TSB - JD00

Models applicable > John Deere 840 to 3140

Details > with 320mm Sachs or Luk diaphragm assembly
Ag Clutch Part Numbers > 133 2701 JD and 133 2301 JD

CLUTCH UPGRADE USING 330mm REPLACEMENT

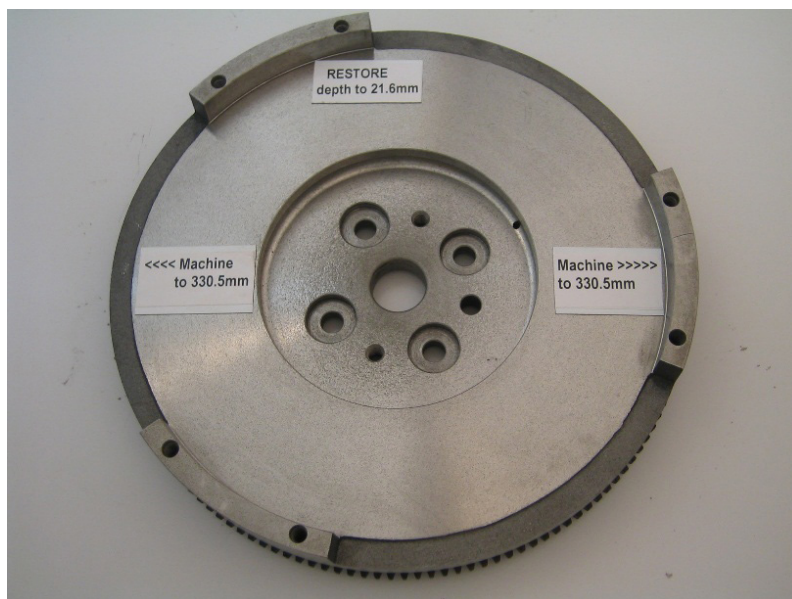
As shown above, the cover mounting surface of the flywheel must be increased to accommodate the larger clutch.

The original diameter = 326.0mm must be machined out to the new diameter of 330.5mm

The flywheel depth must also be restored to 21.6mm (.850in) as per the original specification.

The cover locating studs must be re-fitted using Loctite or a similar retaining compound.
